Jerry Vilander, General Manager
Serrano Water District
18021 Lincoln Street
Villa Park, CA 92861

January 9, 2024

**Mitigated Negative Declaration (MND) for the Proposed Smith Reservoir
Replacement Project (Proposed Project)**

Figure 2-6. Phase 1 Site Plan

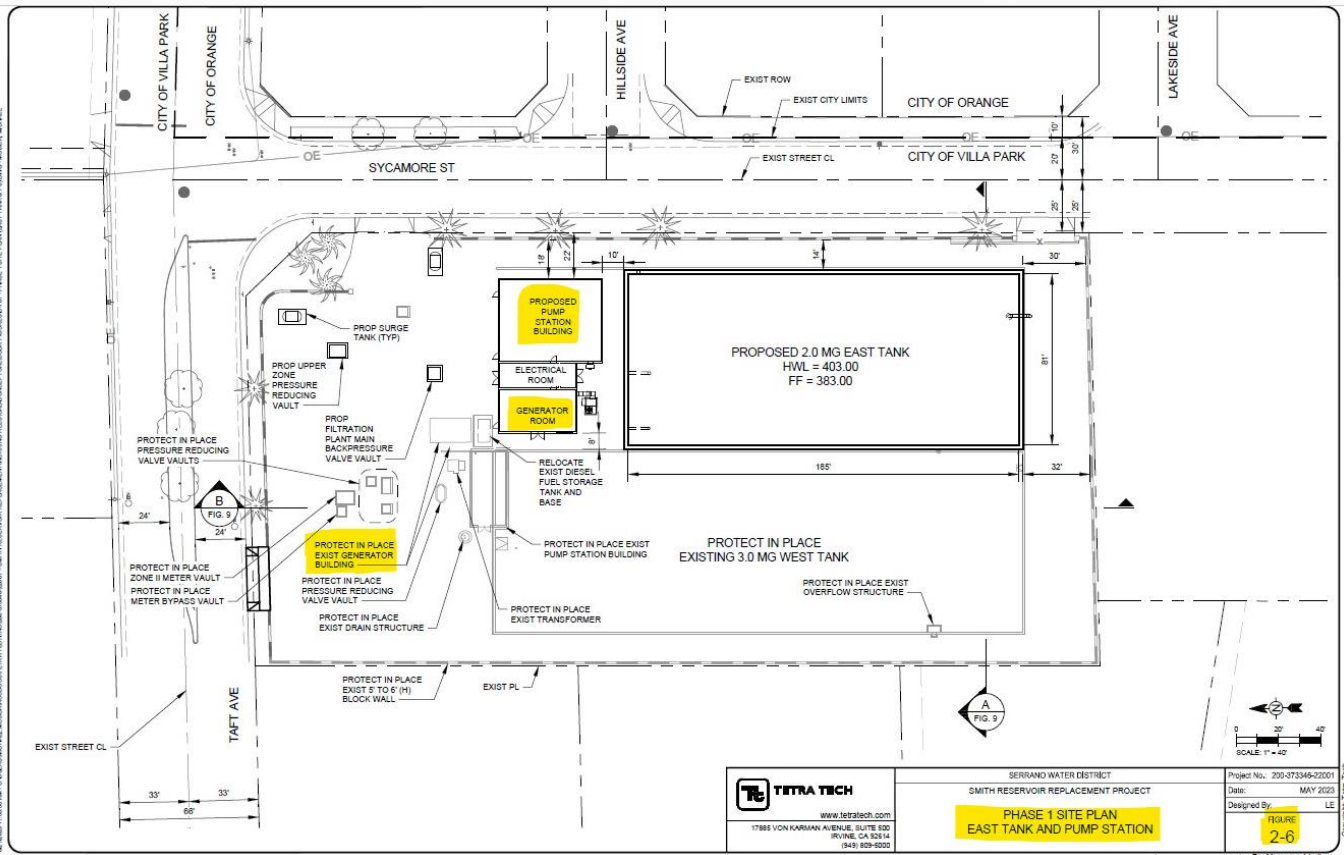
Staff reviewed the MND and notes that construction Phase 1 includes:

- installation of a new emergency standby generator (diesel fueled) and^{11,12}
- construction of a generator room that is in a different location than the existing generator building (see Figure 2-6 below from MND).^{13,14}

For the Proposed Project location, South Coast AQMD records show a facility ID # of 107461. Under this ID # is an active South Coast AQMD air permit (permit #F79108) for one internal combustion engine of 764 brake horsepower (BHP), diesel fueled, and driving an emergency generator. The Lead Agency states in the MND that a South Coast AQMD construction permit will be required.¹⁹ From information provided in the MND, however, Staff is unable to determine what type of South Coast AQMD air permit application will be required for the new emergency standby generator proposed to be installed during

construction Phase 1 (e.g. application for a new permit to operate, application for a permit modification, application for a change of conditions, etc.).
